2409 Plymouth Ave Site Plan Comments

2409 PLYMOUTH AVE
 NOT TO SCALE

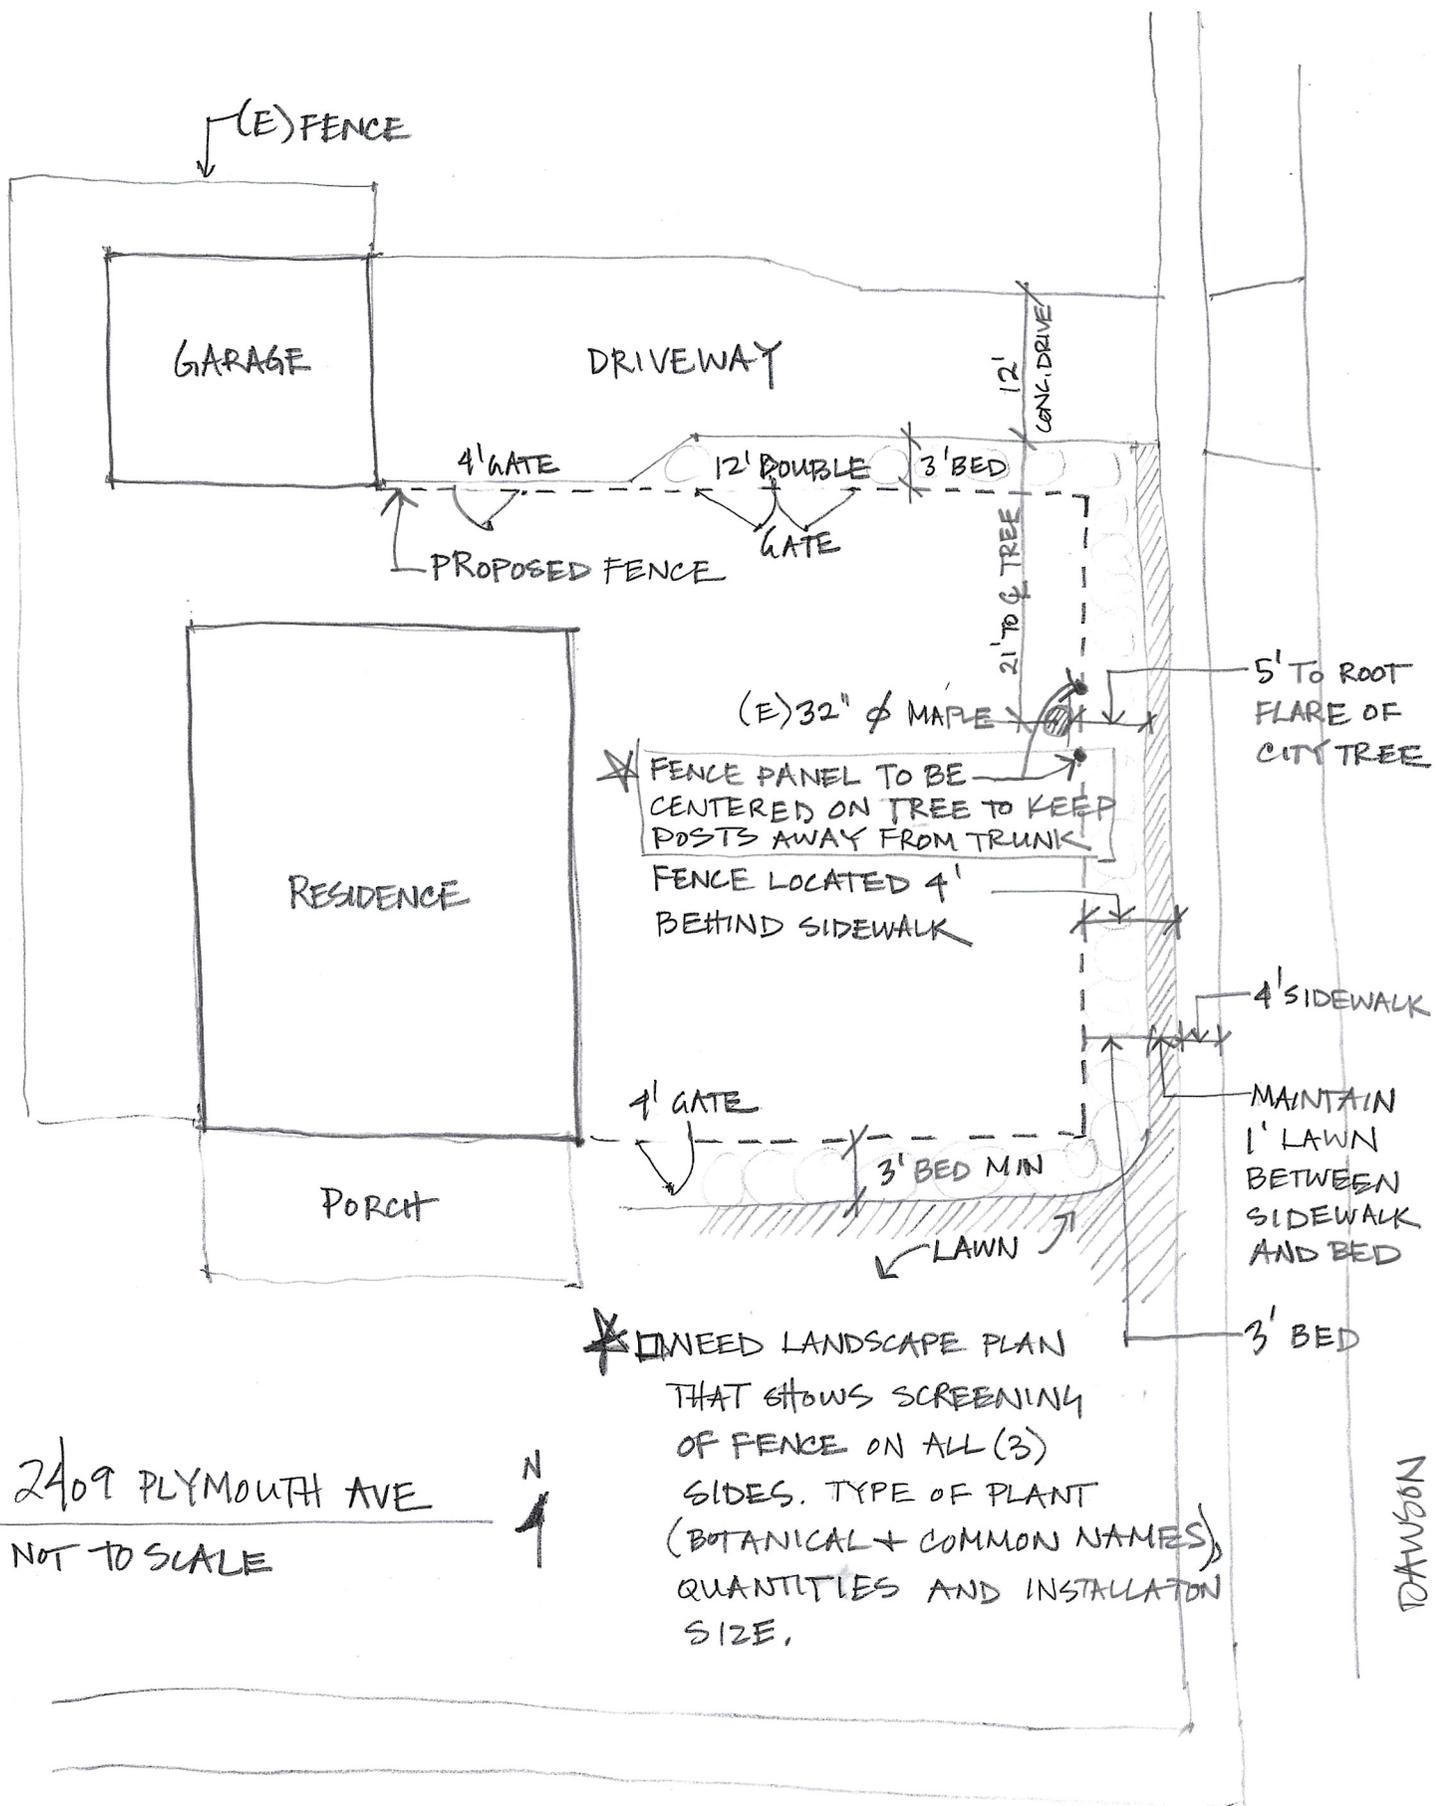
I went out and walked the site at 2409 Plymouth regarding the fence in the ROW. Attached is a quick site plan I sketched that includes my comments. The submitted site plan was not clear and I had some concerns about the scale.

The existing City tree is 5' behind the sidewalk along Dawson. I confirmed with Grant on site that if we had a fence located 4' behind the sidewalk and centered a panel on the tree, that would keep the posts approximately 3' away from the tree on either side which would be healthiest for the tree. (This assumes a 6' standard panel.)

The Tree Commission has been requesting either a 1' lawn panel immediately adjacent to the sidewalk or groundcover that can be maintained in a low strip next to the sidewalk. There are concerns always about lawns sloping down to the sidewalk and mulch obstructing traffic. On this sketch, I am showing a 1' lawn panel (which already is there) and a 3' bed in front of the fence. 3' is a good side bed for them to include boxwood and hydrangea, etc.

The driveway has an angle so I am assuming the north fence line runs straight and provides a 3' bed between the driveway and fence which is ideal for more plants/screening. Obviously there would be a break wherever the 12' double gate is located.

I do need to see a landscape plan that is more detailed than some hydrangea and boxwood. What type? How many? Boxwood and hydrangea are good choices for the site and will provide some winter interest but a plan is needed before a final sign off.

* I NEED LANDSCAPE PLAN THAT SHOWS SCREENING OF FENCE ON ALL (3) SIDES. TYPE OF PLANT (BOTANICAL + COMMON NAMES), QUANTITIES AND INSTALLATION SIZE.
